NRC 2001-004

DOCKETS 50-266 AND 50-301
SUPPLEMENT 10 TO APPLICATION FOR AMENDMENT TO
FACILITY OPERATING LICENSE APPENDIX A:
TECHNICAL SPECIFICATIONS IMPROVEMENT PROJECT
RESPONSE TO RAI ON ITS SECTION 3.7
POINT BEACH NUCLEAR PLANT, UNITS 1 AND 2

DOCKETS 50-266 AND 50-301
RESPONSE TO REQUEST FOR ADDITIONAL INFORMATION
TECHNICAL SPECIFICATIONS IMPROVEMENT PROJECT SECTION 3.7
POINT BEACH NUCLEAR PLANT UNITS 1 AND 2

Table 3.7.1-1 (page 1 of 1)
OPERABLE Main Steam Safety Valves versus
~~Applicable Power in Percent of RATED THERMAL POWER~~

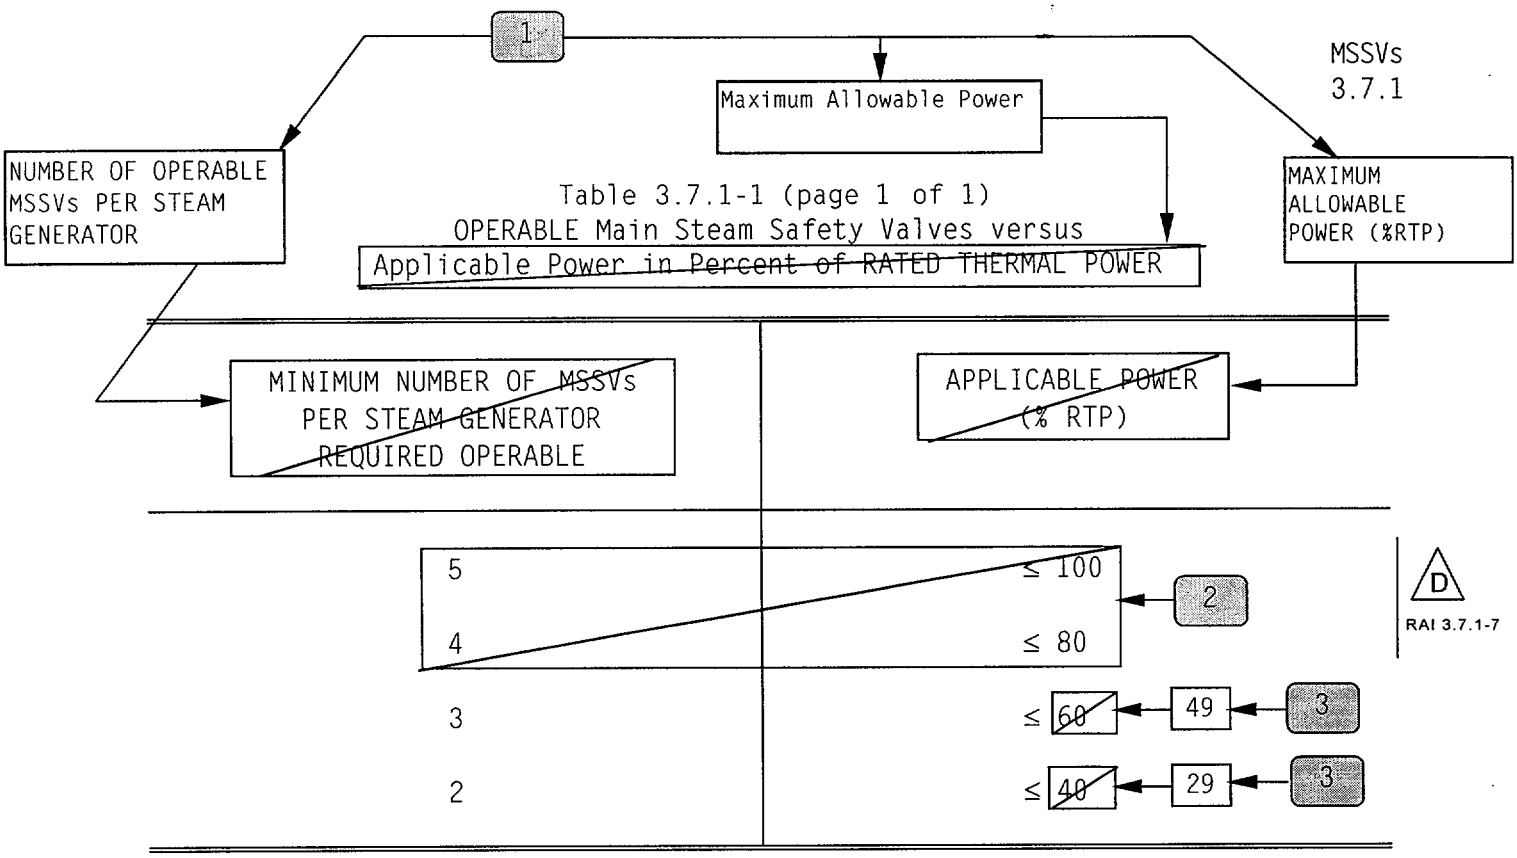
Comment: Revise the referenced requirements and Bases to conform to the STS and TSTF-235, Rev. 1.

(2) Table 3.7.1.1 has been revised to remove the row corresponding to the maximum allowable power when no MSSVs are inoperable, and JFD 2 has been revised accordingly.

Insert 3.7.2-2:

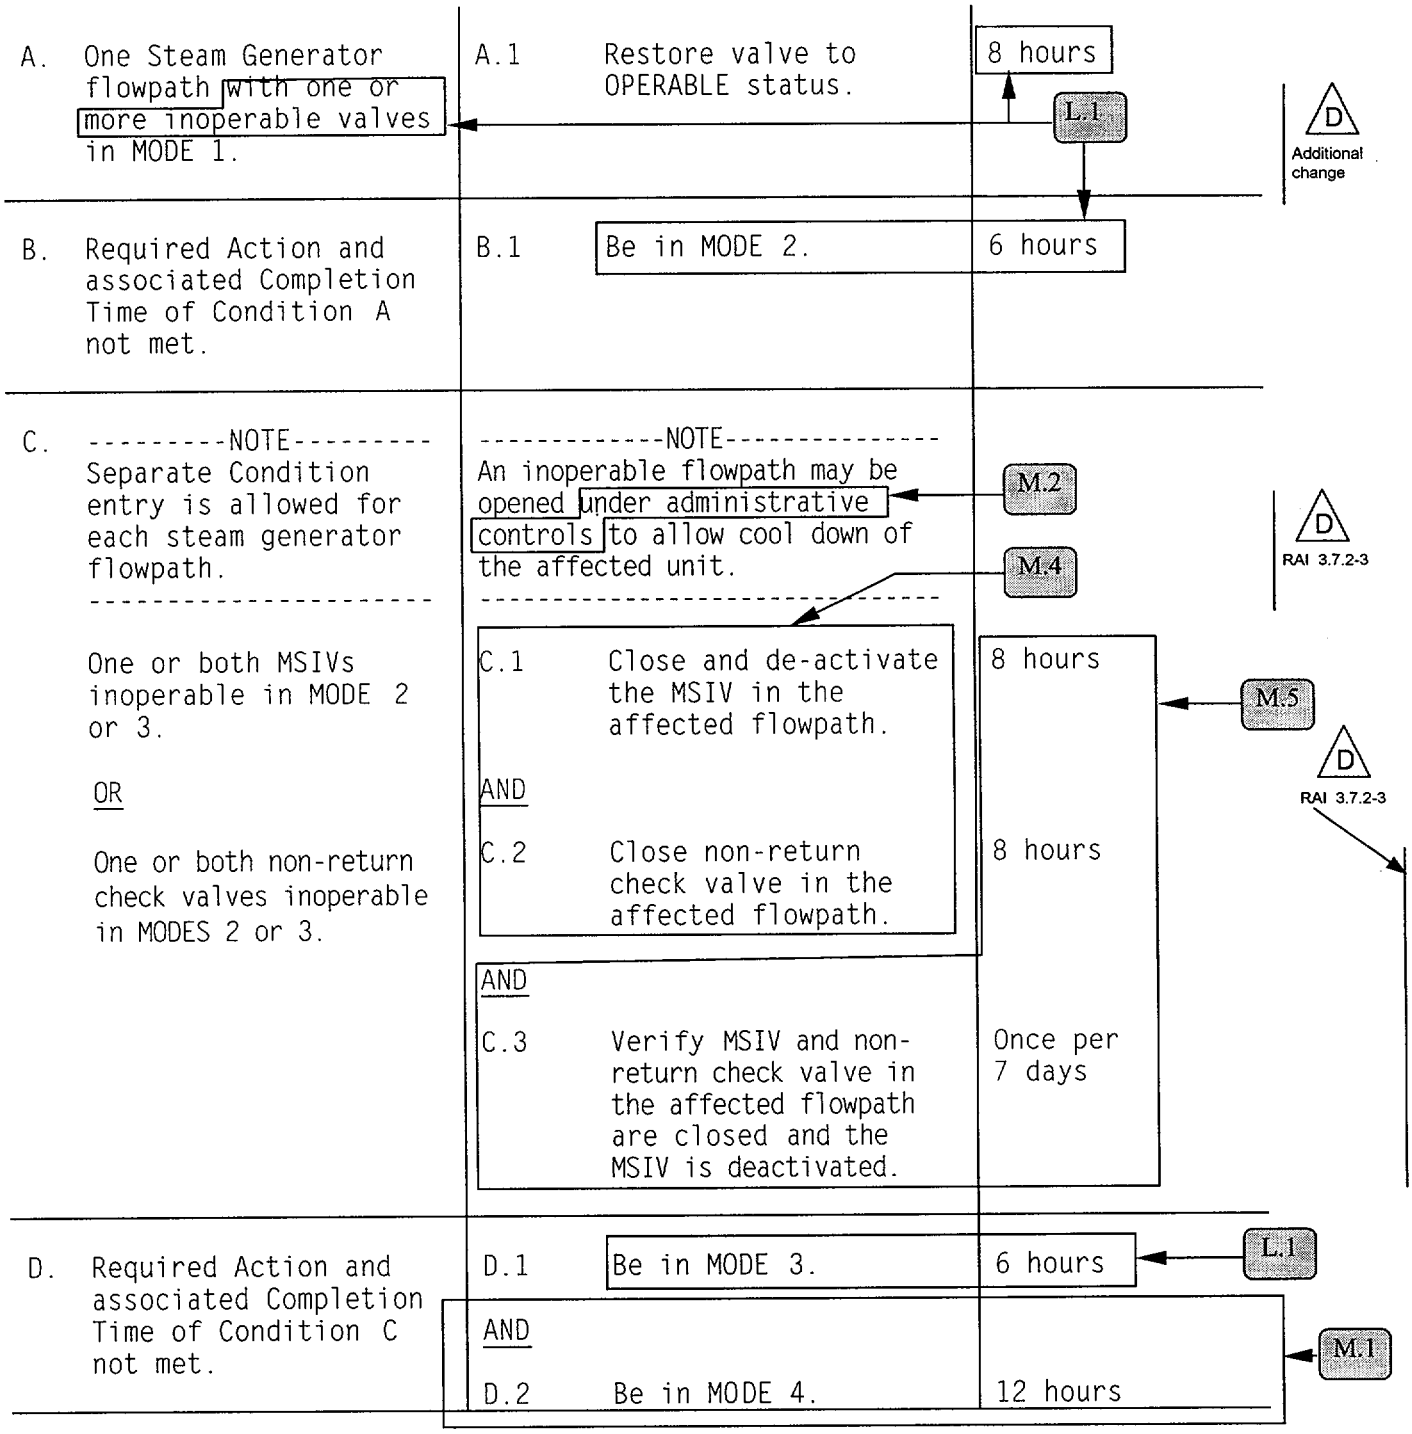
Comment: Revise the CTS insert or ITS insert as appropriate to correct these errors.

(1) CTS Insert 3.7.2-2 for Condition C has been revised to include the missing OR logical connect statement that appears in ITS Insert 3.7.2-2. Also, the CTS markup for Required Action C.3 has been revised to match the ITS markup, subject to the changes made in Item (3) of this RAI.

Insert 3.7.5-2:

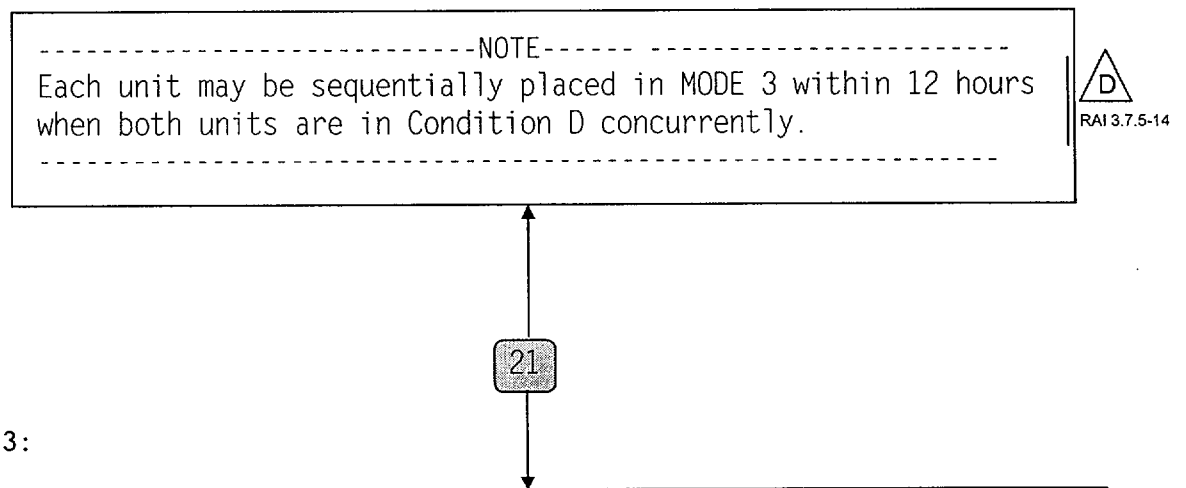
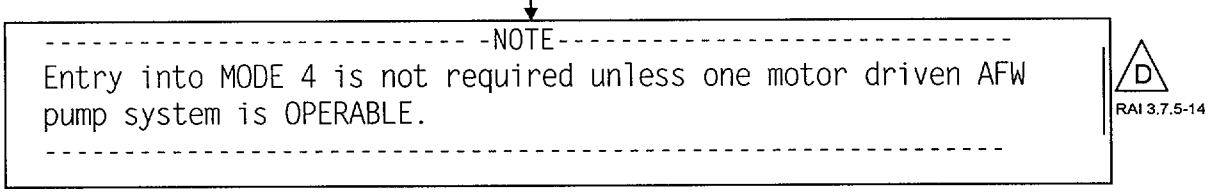
Comment: This is a less-restrictive change as is noted in RAI 3.7.5-4 for DOC M2. There are no specified CTS requirements for a simultaneous shutdown requirement for both units which comes from this new Action D. CTS 3.0.B or ITS LCO 3.0.3 could be applicable. To avoid confusion, it is appropriate to add a note to the column of Required Actions to clarify this potential situation. The Note is "If both units require simultaneous entry into Action D, each unit may be sequentially placed in Mode 3 within [12] hours or less; and entry in Mode 4 depends upon satisfying the Conditions of Action F." The reason for this note is to not prescribe too harsh actions that could jeopardize the timely yet orderly shutdown of both units. The ITS Bases will describe the technical justification for this note and give guidance, for example, that if one unit is already four hours into a Mode 3 shutdown, that the second unit must be shutdown in less than 8 hours [2 hours remaining plus 6 permitted] or in other words 6 hours immediately after placing the first unit in Mode 3. Revise the CTS and ITS markups, DOCs and JFDs as appropriate to add this new Note - or explain why such a note is unnecessary.

The recommended Note to the Required Actions of ITS 3.7.5, Condition D has been adopted. Accordingly, the affected CTS, STS, and ITS pages have been modified, and the Bases have

been changed to provide a technical justification for this change. Also, as a result of the change JFD 21; and DOC L.6, DOC L.7 and the associated NSHCs have been provided.

Figure 3.7.12-1 (page 1 of 1)
Fuel Assembly IFBA Requirements

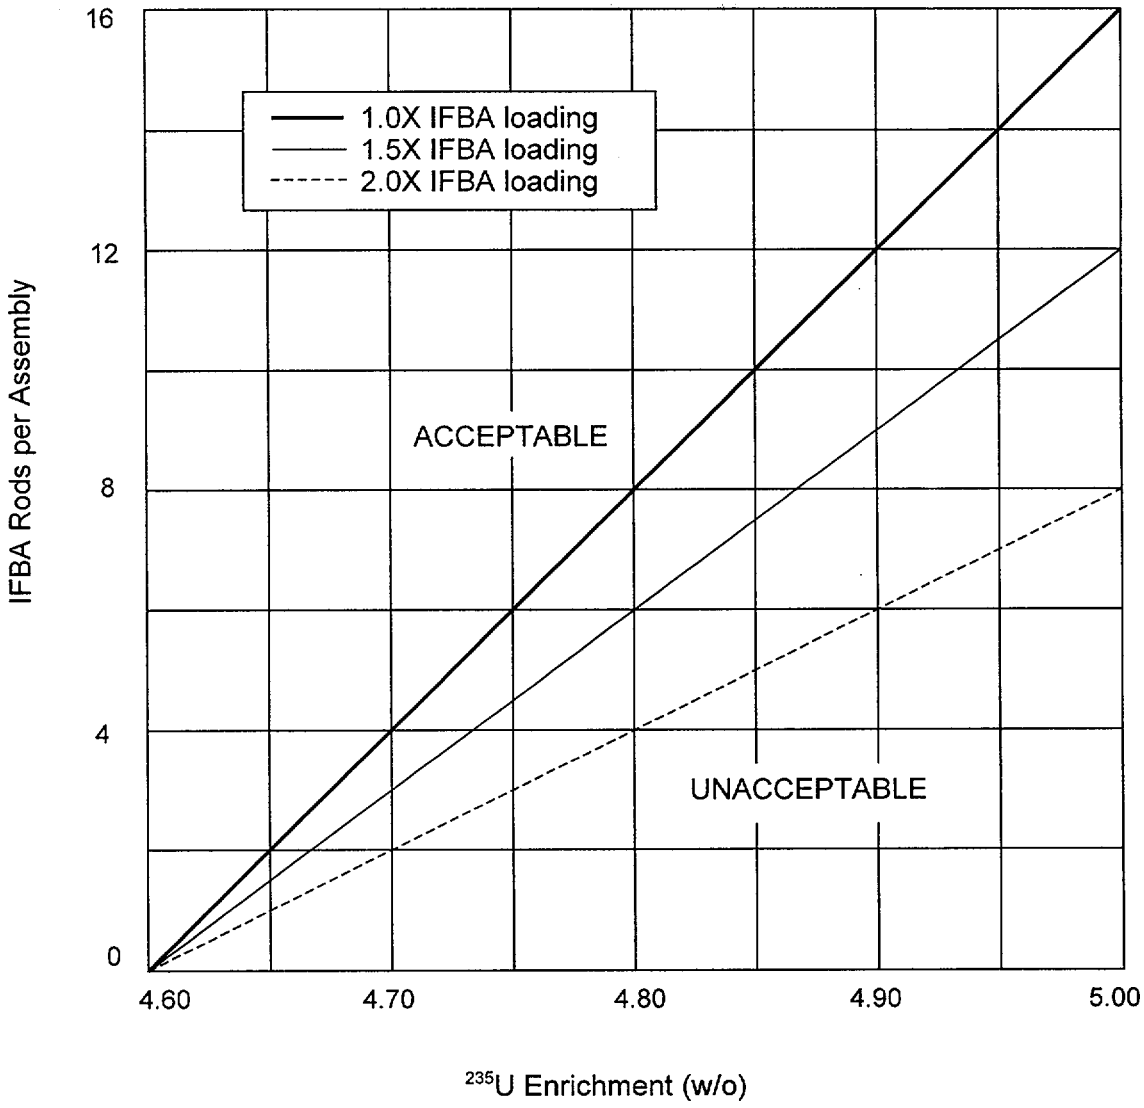
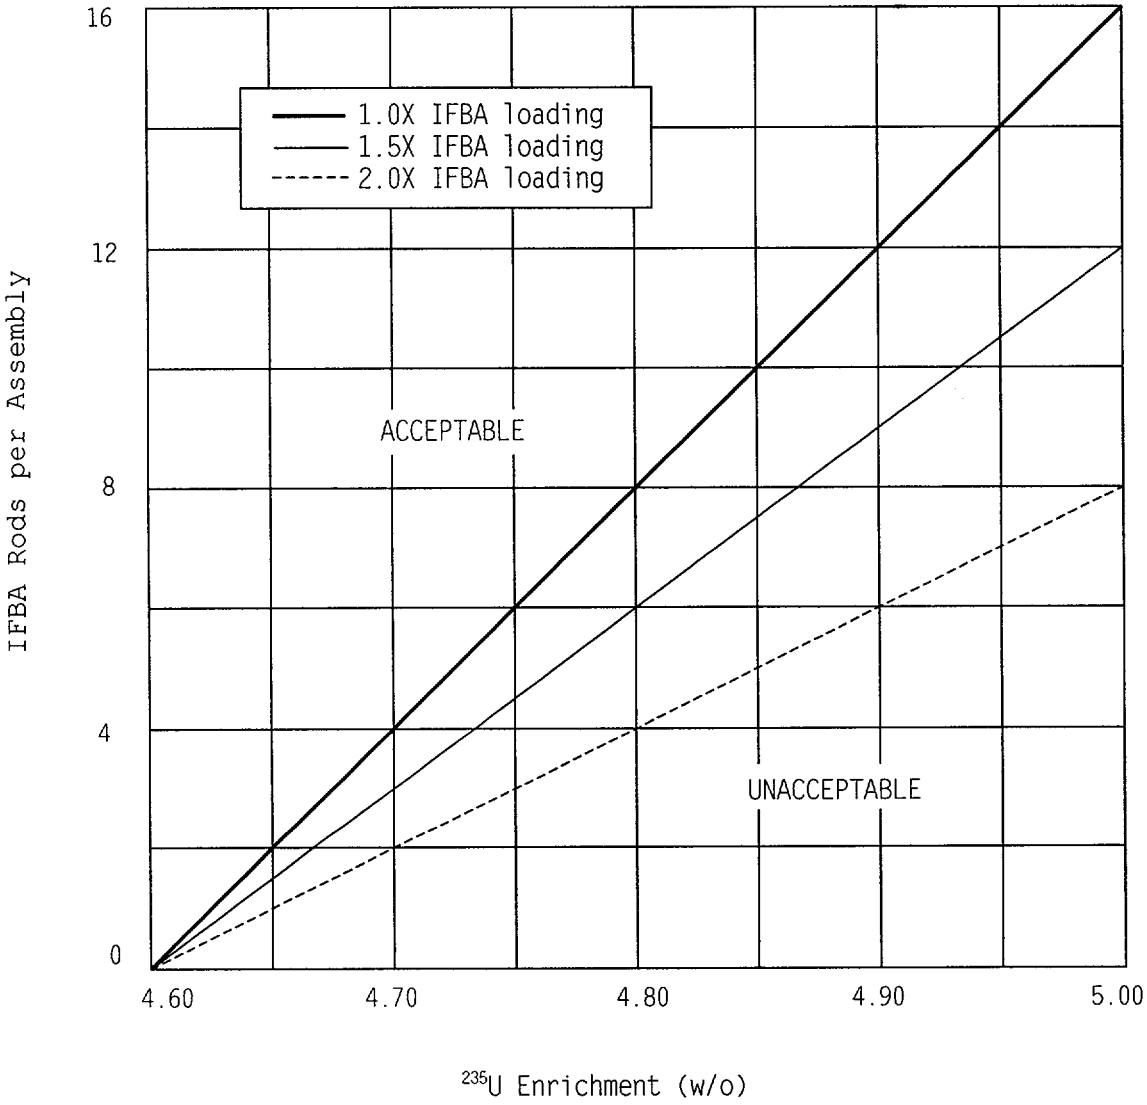
(3) The title from CTS Figure 15.5.4-1, "Fuel Assembly IFBA Requirements" must be retained for ITS Figure 3.7.12-1 because this figure only pertains to IFBA requirements and not to all "Fuel Assembly Storage Limits," as implied.

(3) The title for ITS Figure 3.7.12-1 has been changed to "Fuel Assembly IFBA Requirements." The revised title better describes the intent and limitations of the table and is consistent with the presentation of this information as it appears in the CTS.
